Docket No. 070-03098-ML

In the matter of  
Duke-COGEMA-Stone & Webster (DCS)  
Construction Authorization Request (CAR)  
Mixed-Oxide (MOX) Fuel Fabrication Facility  
Savannah River Site (SRS), South Carolina  
Applicants

AMENDMENT

PETITION TO INTERVENE

MAP 1. Accidental tritium release from SRP. Upper and lower altitude puff path estimates.

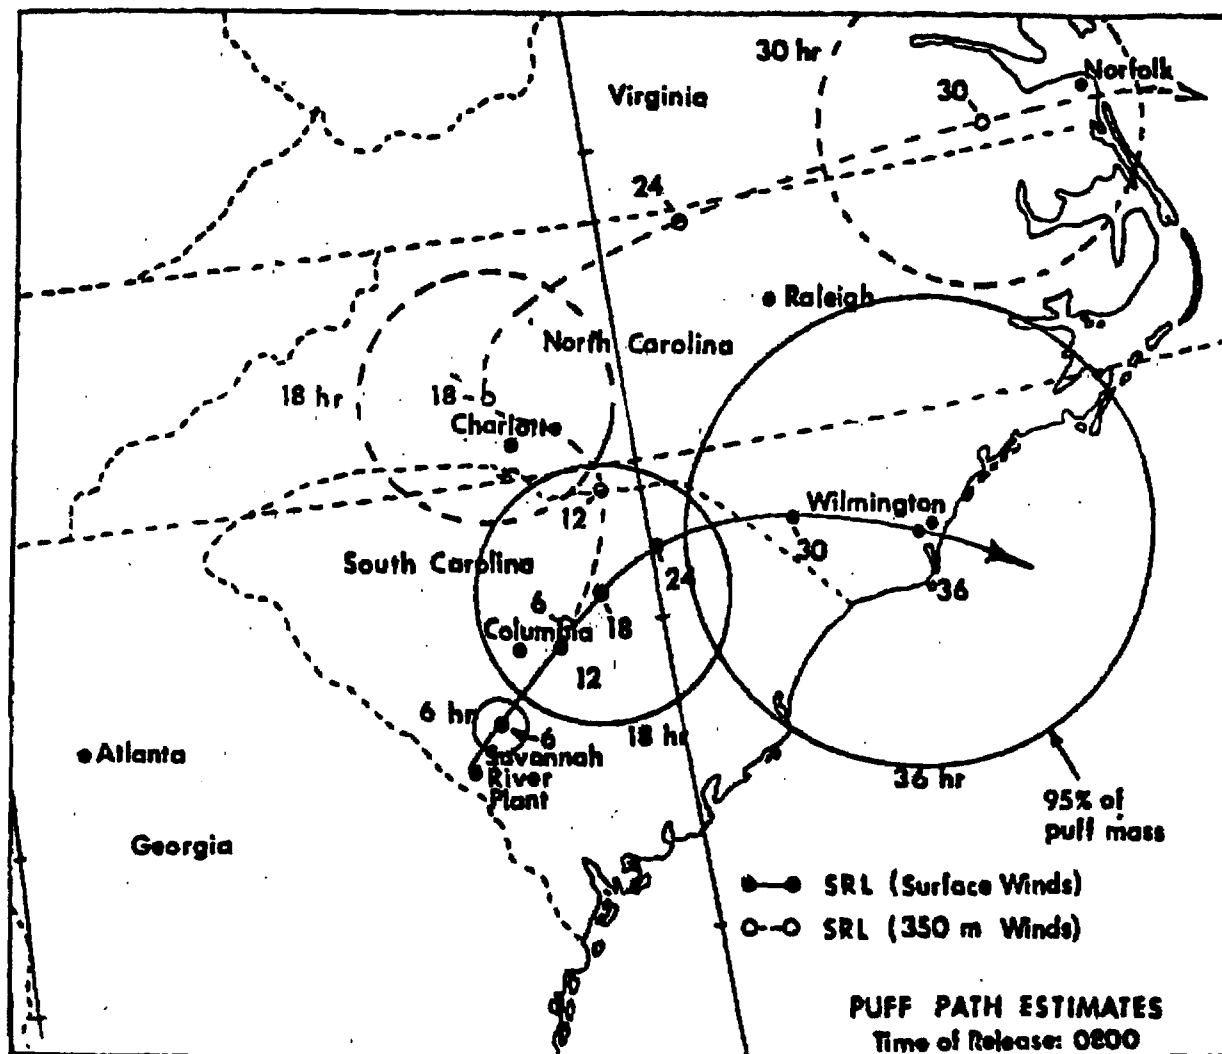
U. The lack of coverage on the subject of fires and their potential for spreading radioactive particulate matter is a flaw which makes the Applicants' evaluations of safety and health impacts invalid. This ties in with the

V. The attached map supports E.I.'s Contentions M, O, P, U, W, and the Affidavit of Basil Garzia.
